**CITY OF ROCKVILLE  
HISTORIC DISTRICT COMMISSION  
STAFF REPORT**

**For  
February 18, 2010 Meeting No. 02-2010**

**APPLICATION:** HDC2010-00489  
**ADDRESS:** 108 N. Adams Street  
**ACCEPTED:** February 1, 2010  
**45-DAY LIMIT:** March 25, 2010  
**OWNERS:** Robert and Colleen Corbey  
**REQUEST:** Rear and side addition  
**STAFF:** Robin D. Ziek

**REQUEST SUMMARY:** The proposed project is for a side and rear addition to a two-story single family house. Part of the addition is one-story and part is two-story. The total added living area is 1230 sf.

PROPOSED FRONT ELEVATION (E)  
SCALE: 1/4"=1'-0"

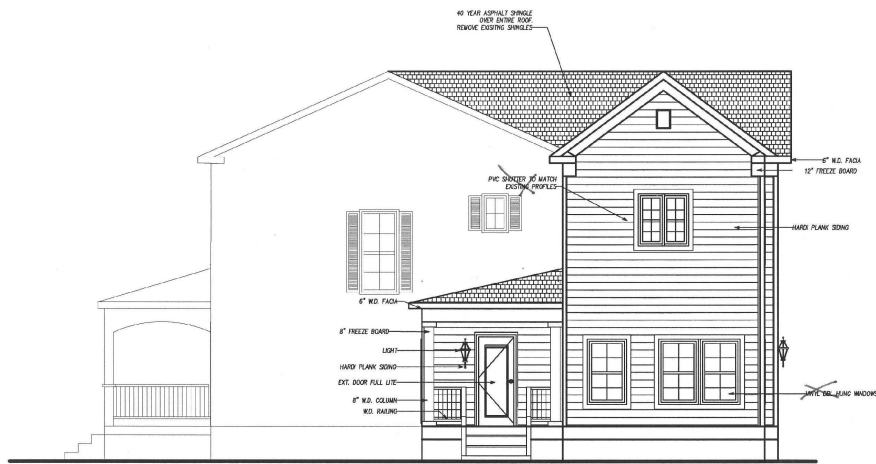
Design: The rear addition extends 15'-8" out from the rear wall of the house, and 10'-0" to the north as a side addition. The footprint provides an additional 680 sf to the house, which currently has a footprint of ca. 760 sf. The second floor addition will provide ca. 550 sf, as part of the proposed new work is only one story.

PROPOSED REAR ELEVATION (W)

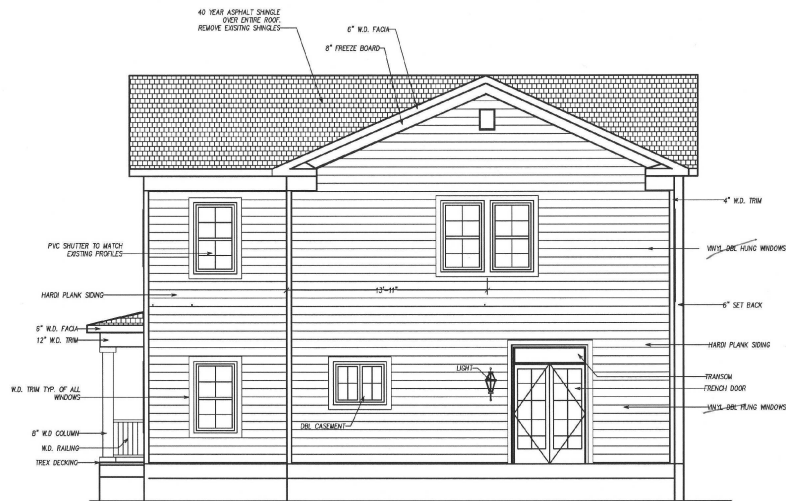
**Height:** The proposed addition matches the height of the existing house (ca. 27'), and staff recommends approval of this based on design development of the addition. The proposed design presents small scale aspects of the addition to the public street so that the existing house will continue to dominate one's view of the house and property. Staff notes then-Staff Winstel recommended at the Courtesy Review that the new addition should be lower than the height of the existing house. At that time, the HDC reviewed abstract massing, and the project has now been developed past that. The roof of the historic resource has a shallow pitch, and Staff now recommends approval with the current design that sets the addition at the same ridge height as the existing house.

The proposed addition is held back from the existing southwest corner to more clearly preserve the original massing. In addition, the length of the west elevation of the proposed addition (36'-10") is broken up by stepping in the northwest corner room, providing a smaller scale to the project when viewed from the adjacent properties to the west.

Smaller  
2/2 sash  
on north  
elevation

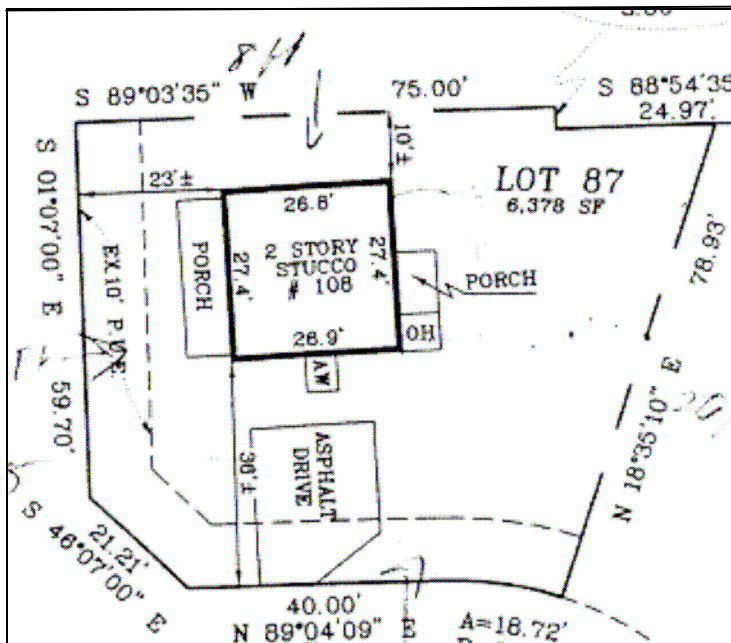
The new windows are proposed to be Anderson aluminum-clad wood, with simulated true-divided light muntins. The new windows will have similar profiles to the original, but they won't replicate them. This will provide additional differentiation between the old and new. Staff notes that the 2/2 windows of the original house are typical of late 19<sup>th</sup> century windows, and an indication of the early age of the underlying elements of the existing house. The 2/2 configuration reflected advanced window technology, which made possible large panes of glass to provide more light inside the building. Staff has concerns with the proposed removal of a 2/2 window on the west elevation and a smaller window in the north elevation. These window elements are character-defining elements at this site, providing a link to construction earlier than the 1928 date given for the house.

- Conditions:
1. The HardiPlank clapboard shall have a smooth “wood” finish.
  2. The existing windows proposed for removal shall be evaluated for repair and incorporated into the project to retain associated historic materials on site.

Proposed Site Plan  
[staff drawing]

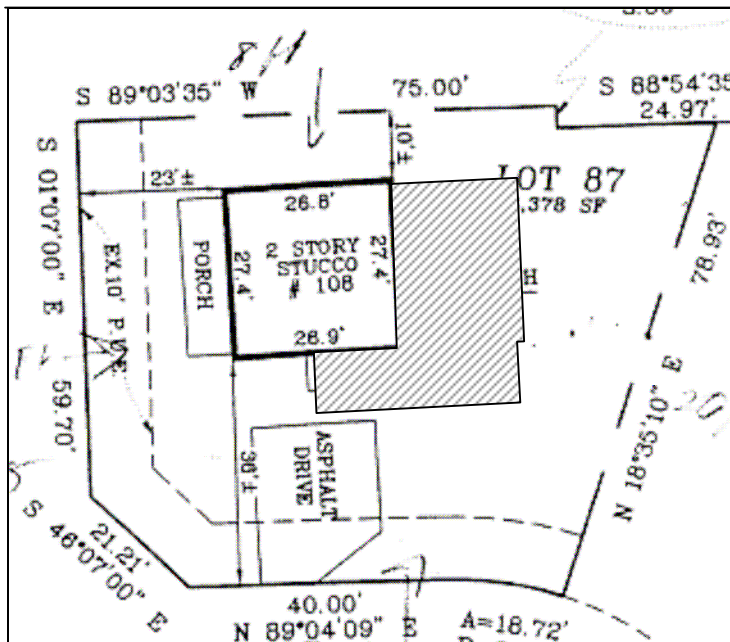
Lot coverage: The proposed project is well under the maximum lot coverage of 35%, with a proposed 22% lot coverage.
